APPEAL SUMMARY

Appeal ID: 22156	Project Address: 2545 SW Terwilliger Blvd
Hearing Date: 11/20/19	Appellant Name: Joshua Klyber
Case No.: B-018	Appellant Phone: 5034885651
Appeal Type: Building	Plans Examiner/Inspector: Suzan Poisner
Project Type: commercial	Stories: 7 Occupancy: R-2, S-2 Construction Type: I-A
Building/Business Name: Terrace at Terwilliger Plaza	Fire Sprinklers: Yes - Throughout
Appeal Involves: Alteration of an existing structure	LUR or Permit Application No.:
Plan Submitted Option: pdf [File 1]	Proposed use: Independent Senior Living

Appeal item 1

Code Section OSSC 3104.5 - Fire Barriers Between Pedestrian Walkways and Buildings

2 HR Rating at Sky Bridge Connection at EXISTING BLDG. - LEVEL 6

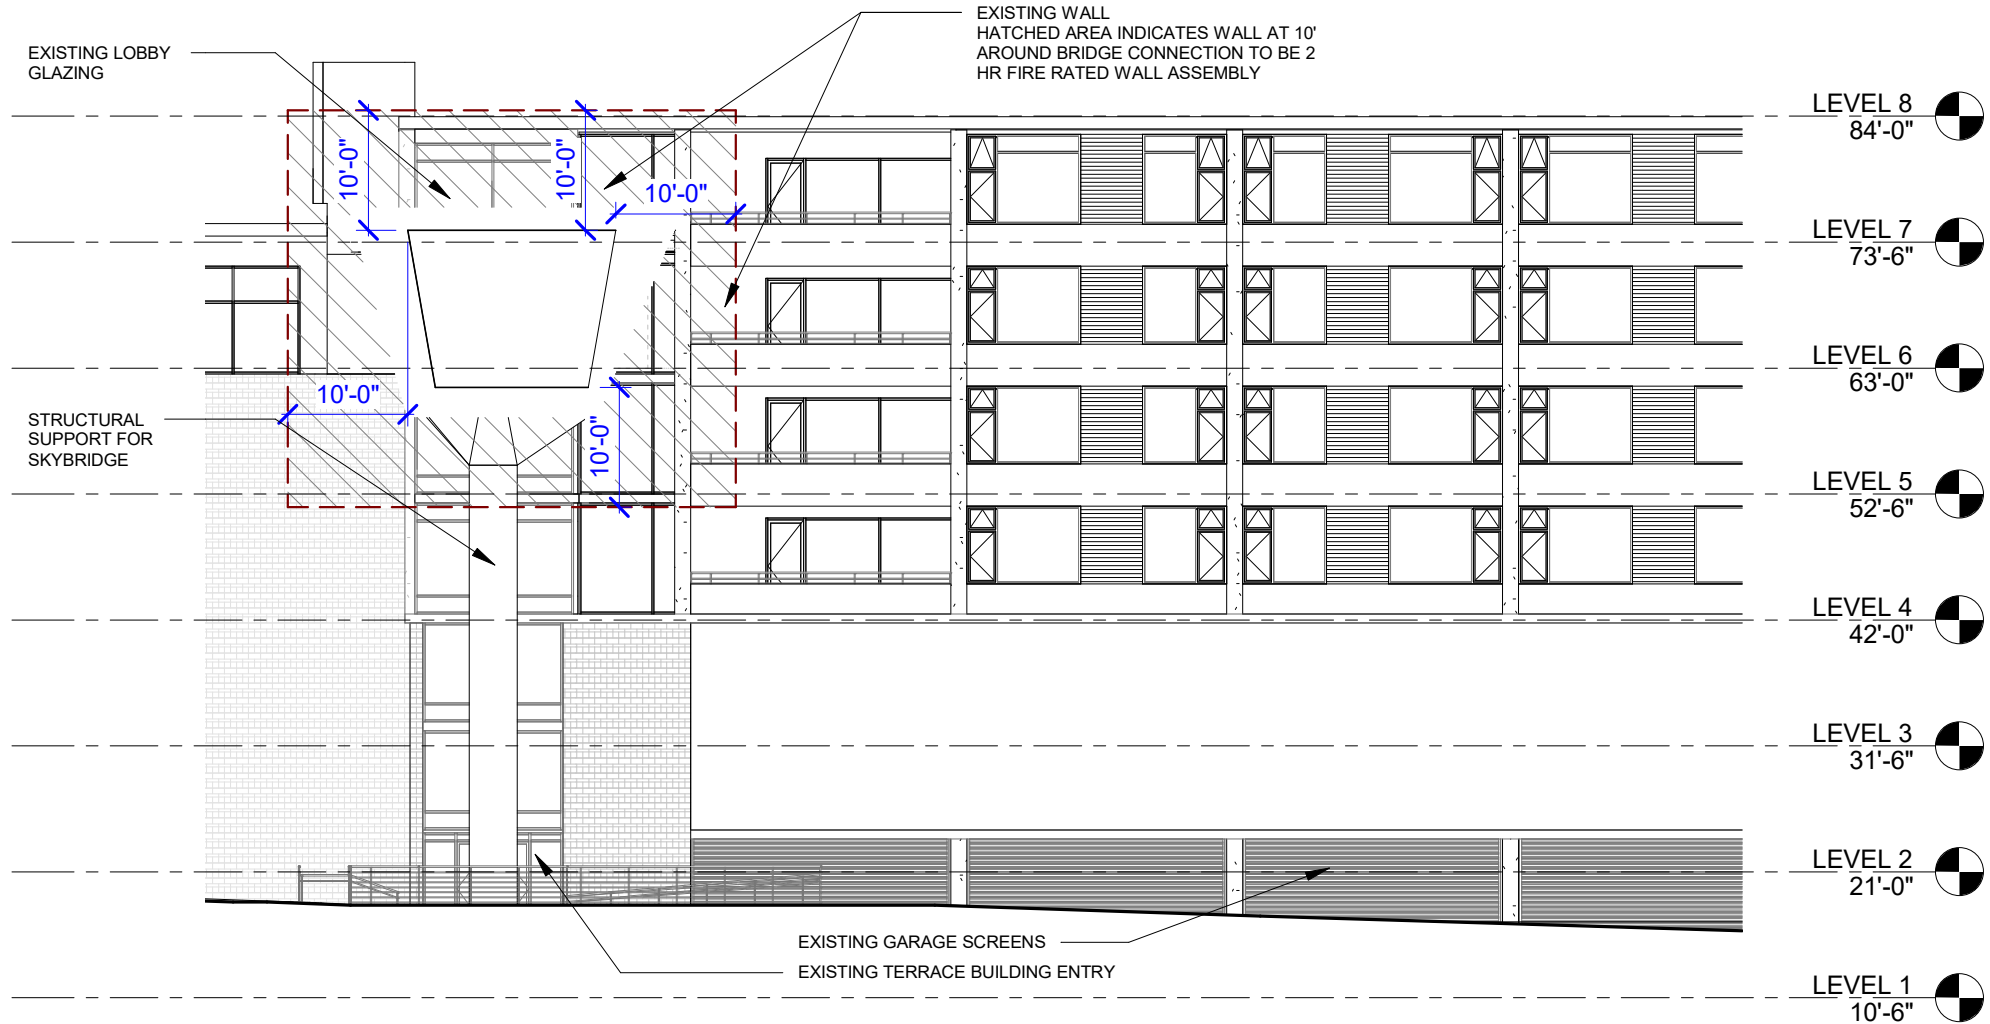
The proposed design for the existing building has windows located within 10 feet of the pedestrian walkway. These windows will be provided with Tyco Model WS sprinklers on each side of the window per ICC ESR-2397 to provide equivalency to a 2-hour fire-resistance rating, which exceeds the requirement for 45 minute fire rated opening protection.

The proposed assembly will be designed to meet the specifications of Section 4 of the ICC ESR-2397 report. The fixed glazed assembly will not have intermediate horizontal mullions that would interfere with uniform distribution of water. All combustible materials will be kept a minimum of 2 inches from the face of the glass, such that complete coverage of the glass by the sprinklers is not impeded.

Therefore, it is requested that glazing protected by Tyco sprinklers on both sides installed in accordance with ICC ESR-2397 be accepted within 10 feet of the pedestrian walkway.

Protection of non-rated glazing within 10' of pedestrian walkway w / Tyco WS sprinklers: Granted provided sprinklers are installed per ICC ESR-2397 and manufacturers specifications.
